SUBJECT: Grand Gulf Nuclear Station
Units 1 and 2
Docket Nos. 50-416 and 50-417
License No. NPF-13
File 0260/0272/0756
Responses to NRC Request for
Additional Information on
Hydrogen Control
AECM-84/0114

REQUEST FOR ADDITIONAL INFORMATION
1/4 SCALE MARK III
H₂ COMBUSTION TEST PROGRAM

FIGURE 1
H₂ IGNITER ASSEMBLY

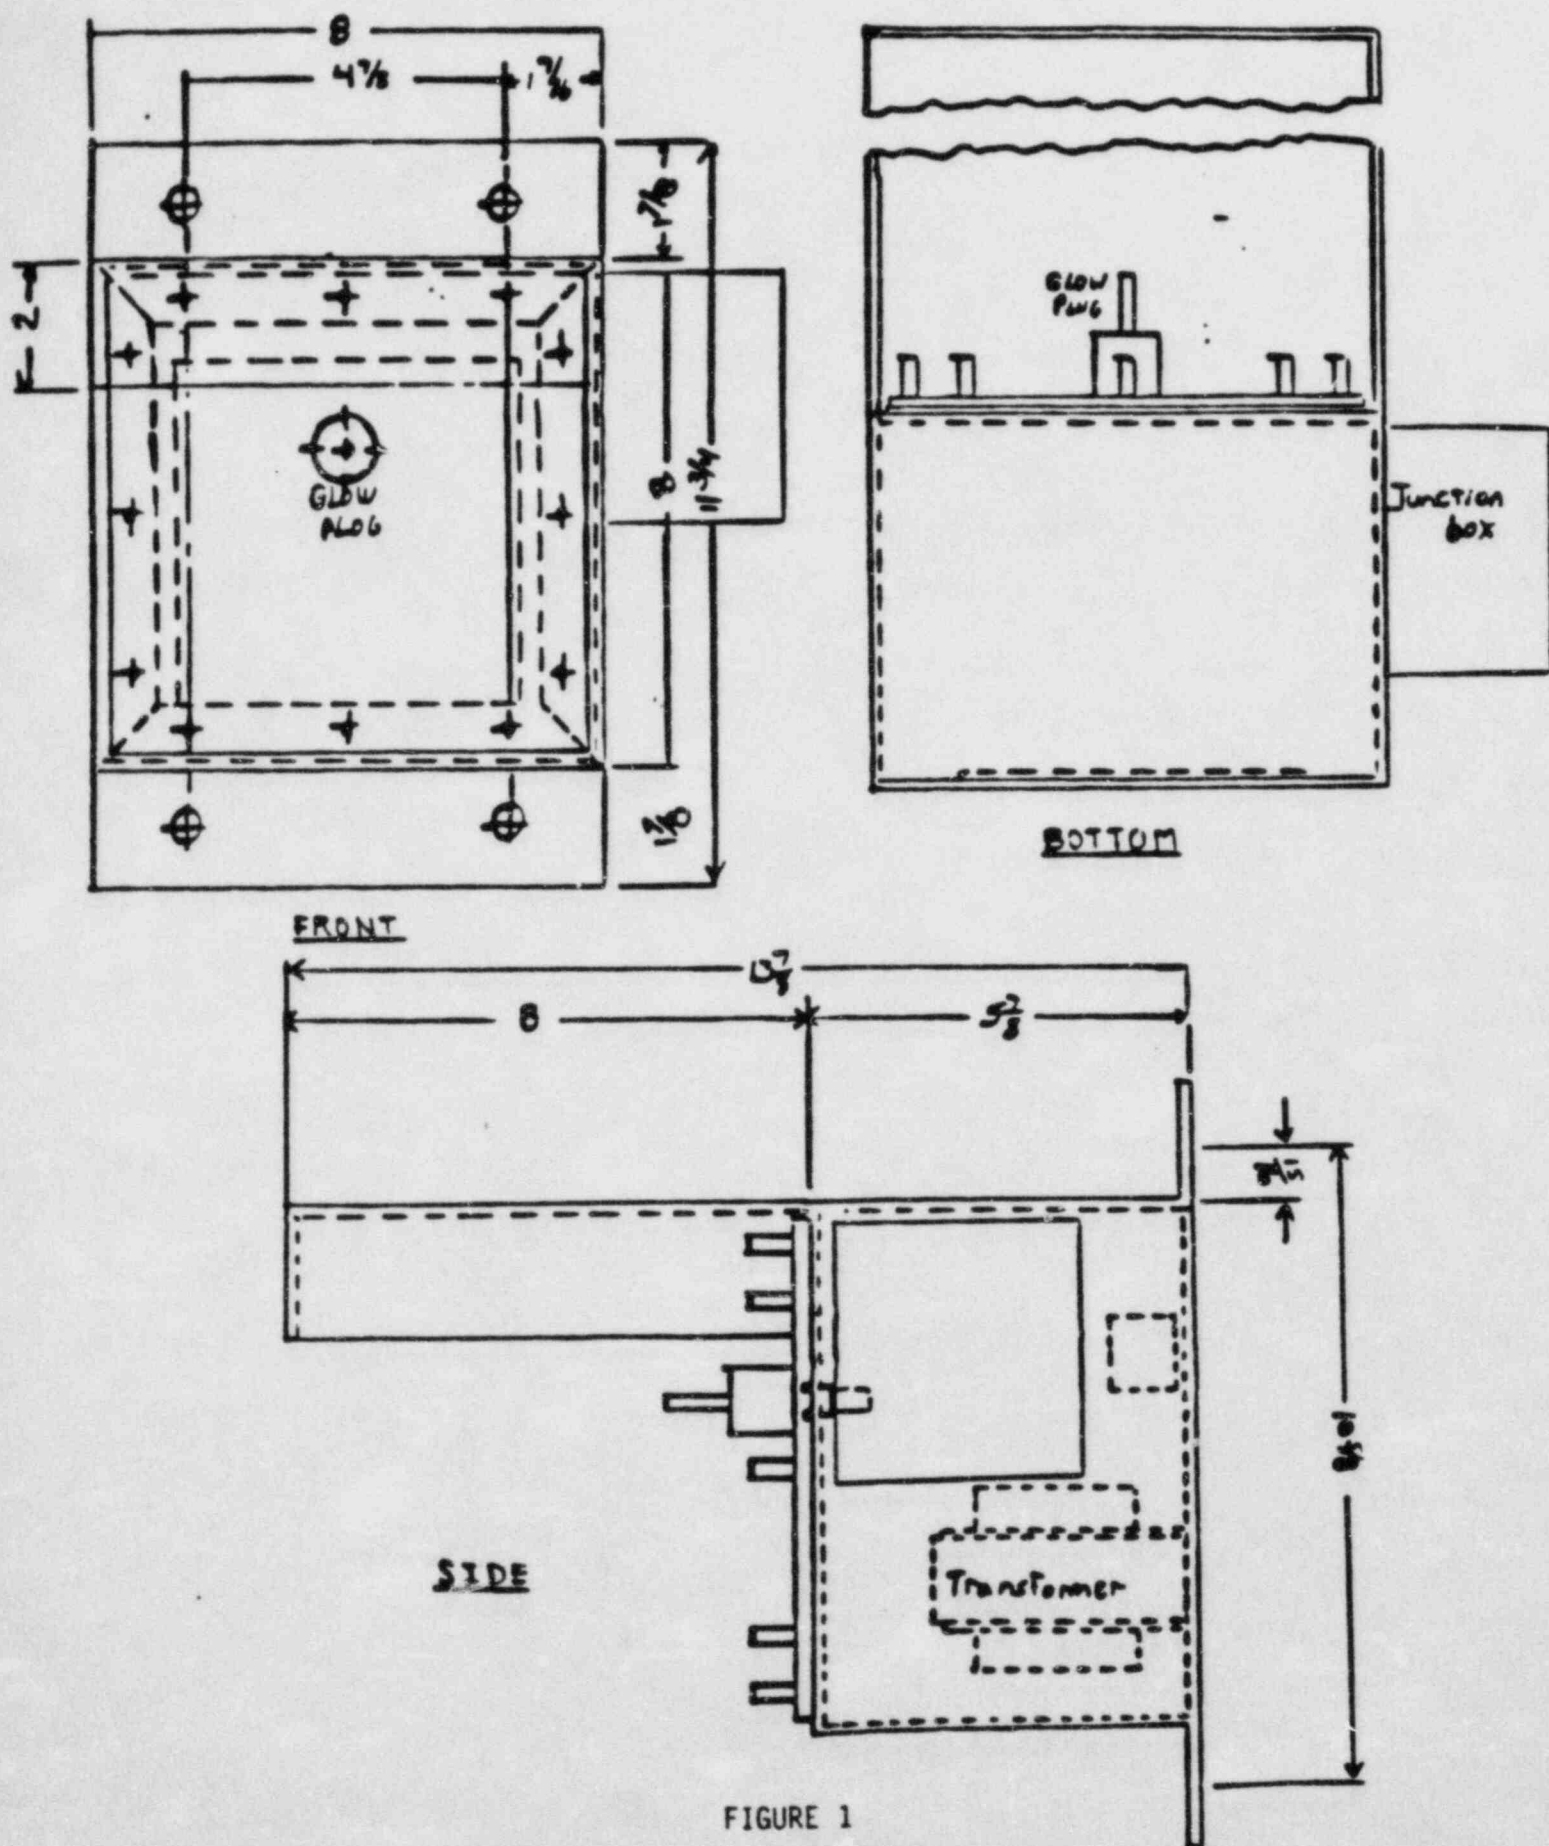
4. It appears from the equipment temperature response curves that the initial temperature of all the equipment is considered the same irrespective of the energized condition of the equipment. Justification is required as to why the energized condition for certain components e.g. solenoid valve, pump motor etc., will not result in higher initial temperatures.

The igniter assembly is an 8" x 8" x 6" stainless steel box with a removable access cover. It houses the transformer and terminal strip mounted on a stainless steel plate and also contains the associated wiring. The glow plug extends out through the front and is assumed to be insulated from the box by the glow plug mount. The assembly is shown in Figure 1.

FIGURE-1

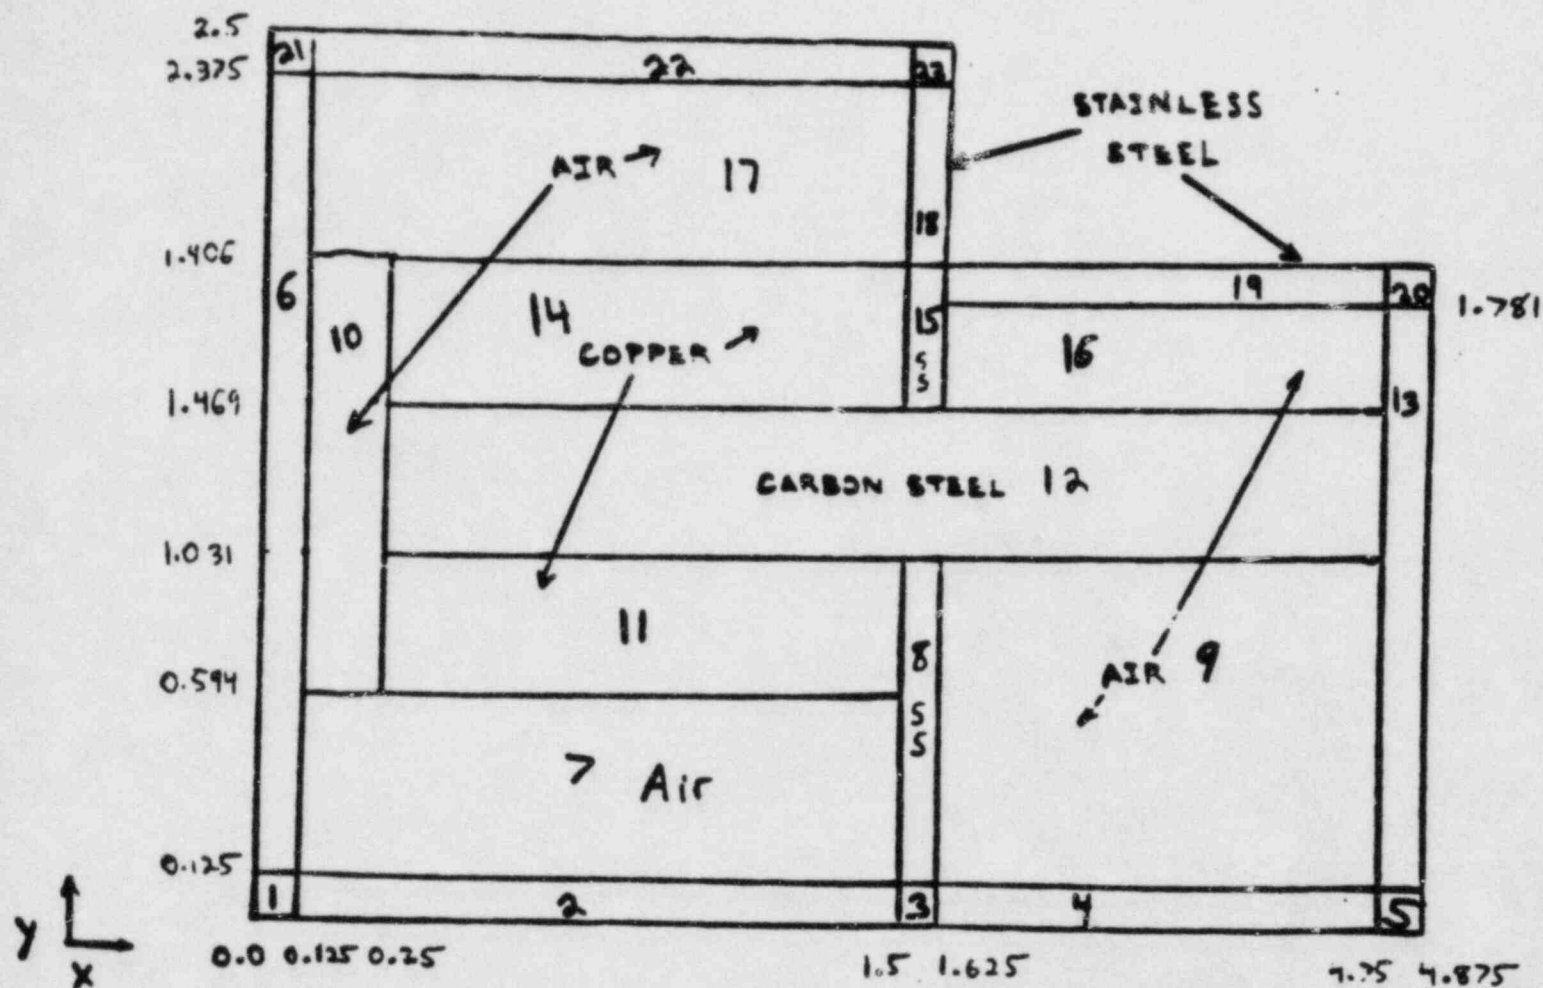
5. The surface temperature of the equipment is not to be measured during the qualification testing. The applicant should provide the surface temperature of the equipment during qualification testing by using the same analytical method used to calculate surface temperature of the equipment during a hydrogen burn event.

In order to demonstrate that the outer surface temperature of these components follows closely the ambient gas temperatures during the qualification testing, similar calculations were performed using the same analytical method and models (see Figures 1, 2 and 5). It should be noted however, that the modes of heat transfer in the qualification test and burn environments are significantly different. The qualification environment is characterized by condensation while heat transfer in the burn environment is controlled by radiation and convection.
